REQUEST FOR CONDITIONAL USE (SPECIAL EXCEPTION)

Re: Entrance ROW Width Variance Narrative
Yocona Springs Subdivision
Lafayette County, Mississippi

CONSTRUCTION PLANS FOR: YOCONA SPRINGS SUBDIVISION

Concerns w/ Subdivision

Sewer
Plan

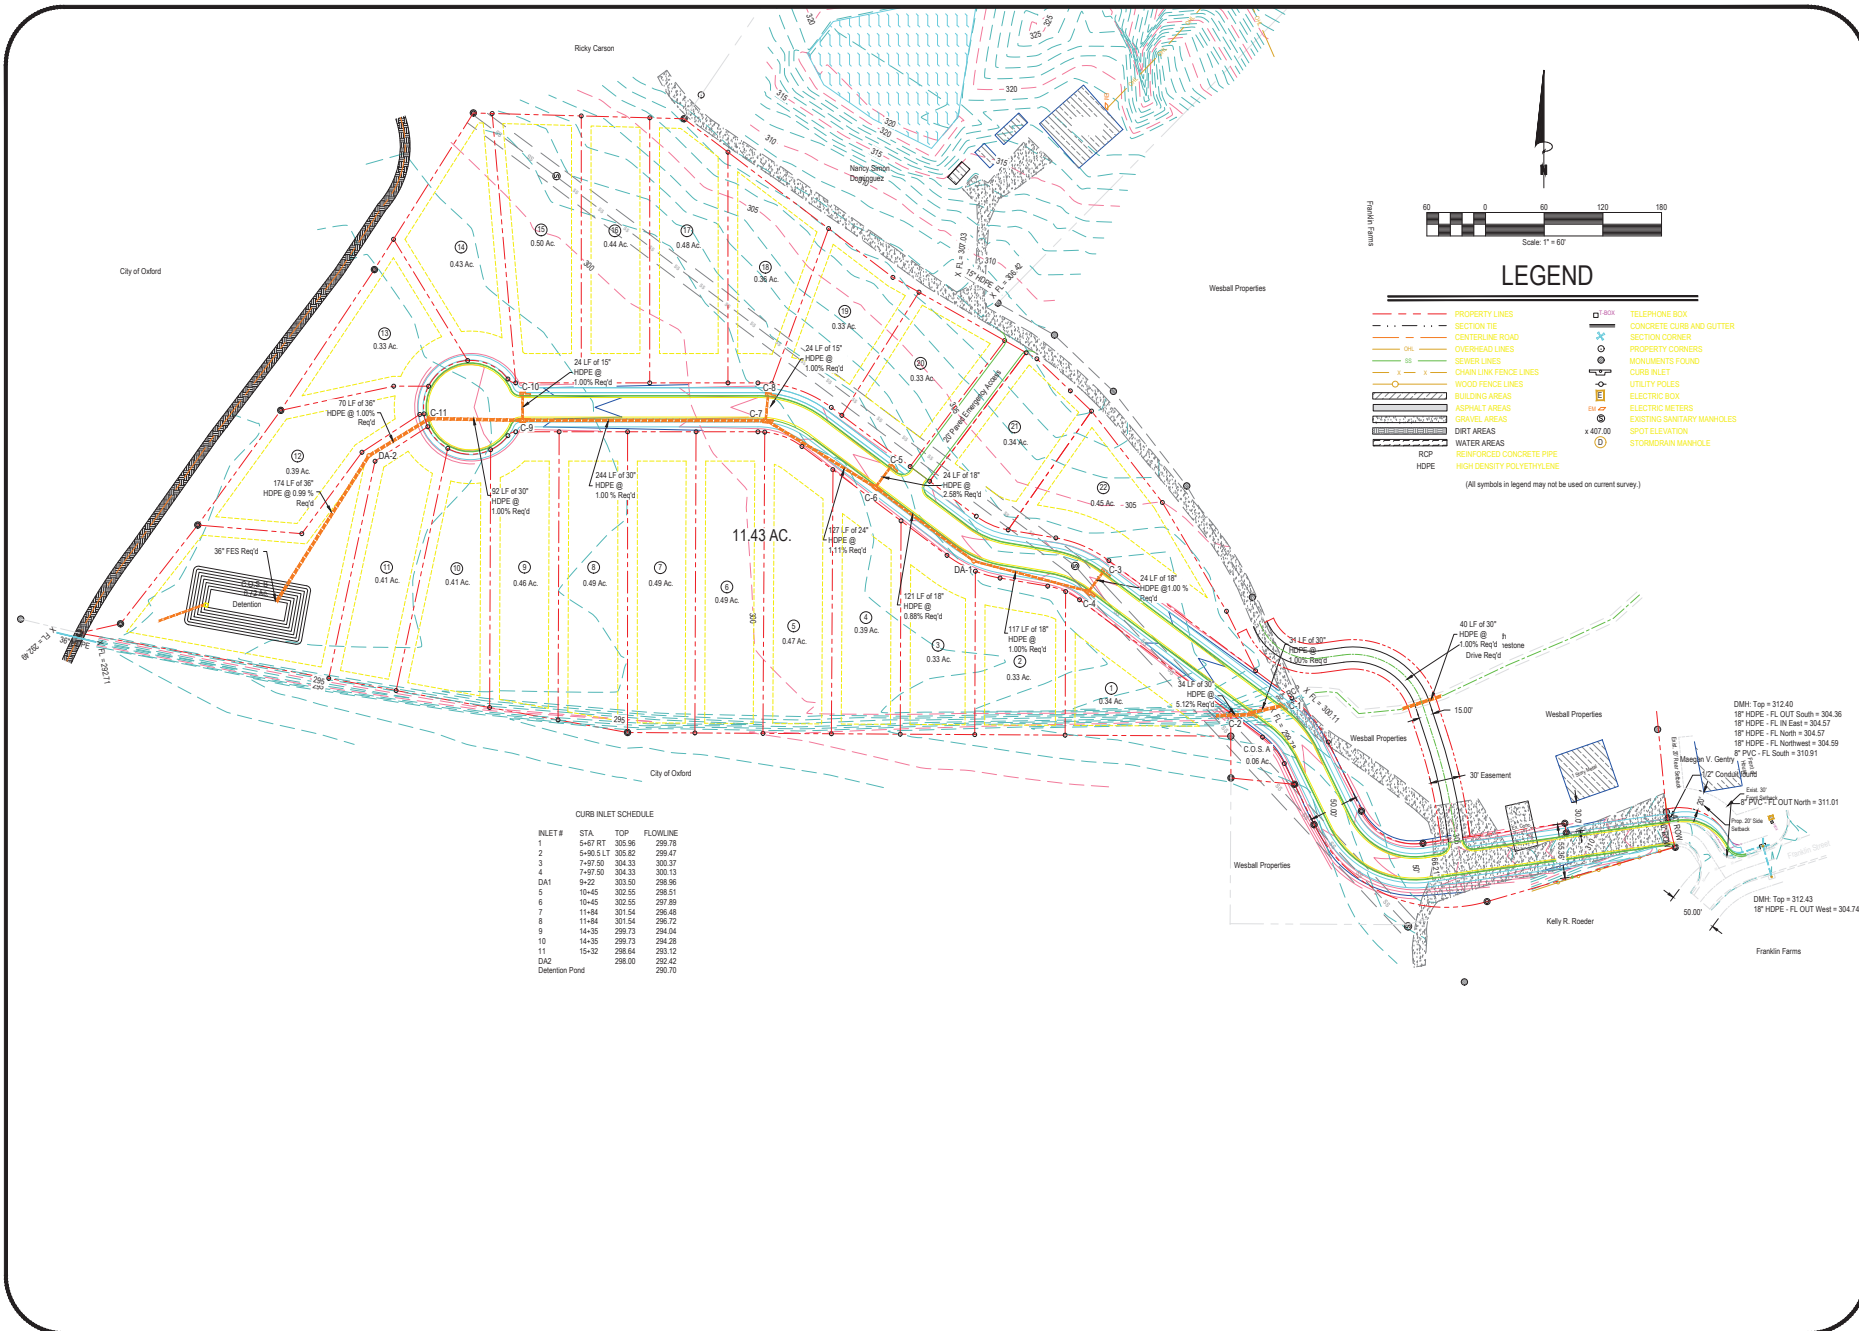
Second, I have concerns regarding the proposed houses and the existing City of Oxford sewer infrastructure. It appears that four of the proposed houses are located over or in the area of existing city sewer manholes. I would like clarification regarding how the proposed development will affect these sewer manholes and the existing sewer system, including whether the homes, driveways, or other improvements will interfere with access to or maintenance of the sewer infrastructure.
